SLOVENSKI STANDARD
SIST EN 15269-5:2014/kFprA1:2016
01-januar-2016

Extended application of test results for fire resistance and/or smoke control for door, shutter and openable window assemblies, including their elements of building hardware - Part 5: Fire resistance of hinged and pivoted metal framed glazed doorsets and openable windows

FINAL DRAFT
EN 15269-5:2014
FprA1

Extended application of test results for fire resistance and/or smoke control for door, shutter and openable window assemblies, including their elements of building hardware - Part 5: Fire resistance of hinged and pivoted metal framed glazed doorsets and openable windows

3 Modification to Table A.1, rule B.4.16

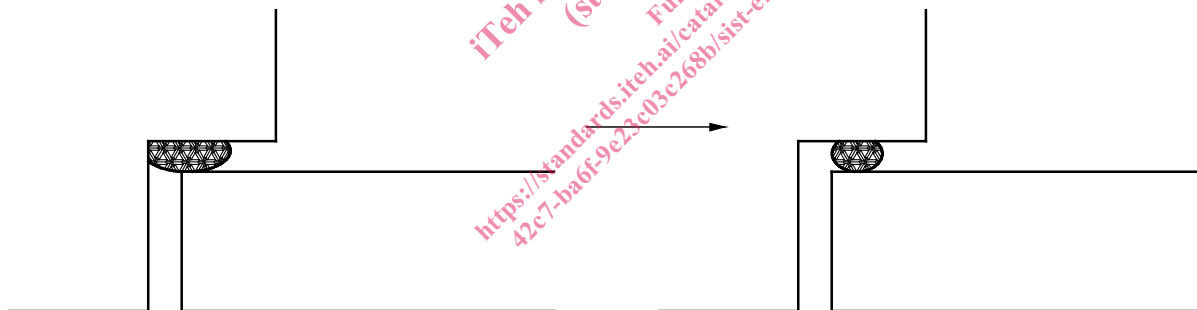
Add the following text in column (5):

"Additional test can be single or double leaf doorset with toplight"

5 Modification to Figure A.25

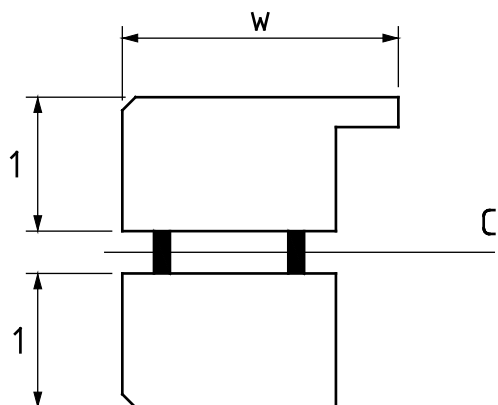
Replace existing figure with the following:

6 Modification to Figure A.27

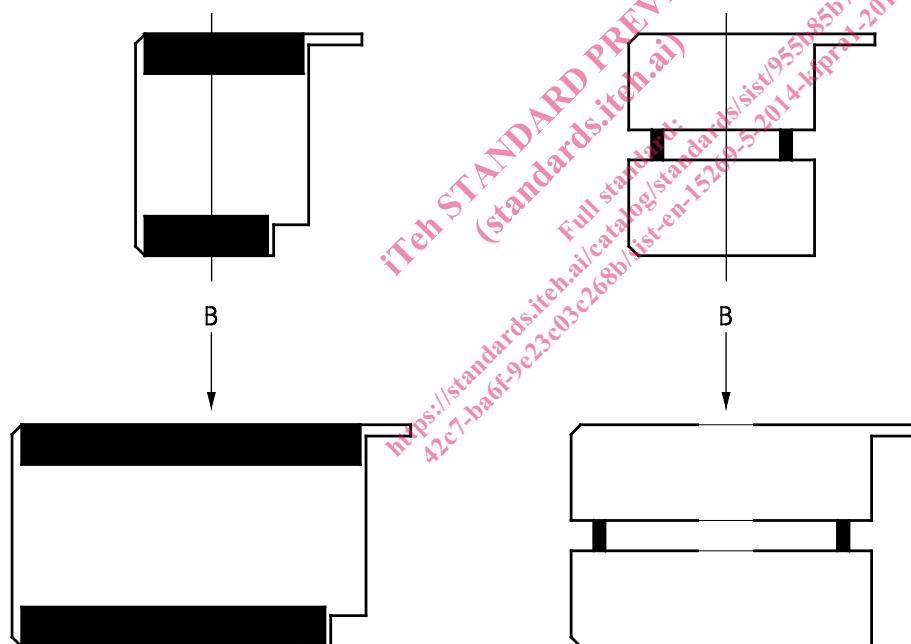
Replace existing figure with the following:

7 Modification to Figure A.30

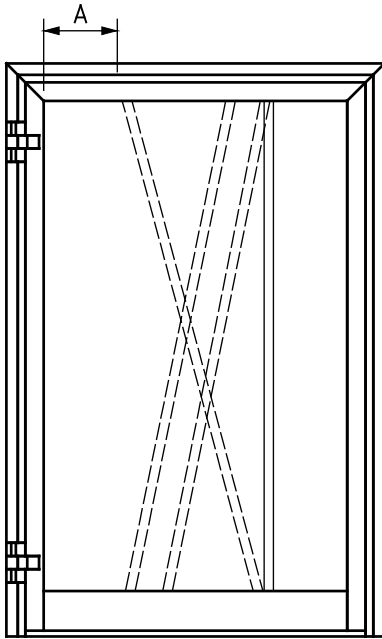
Replace existing figure with the following:
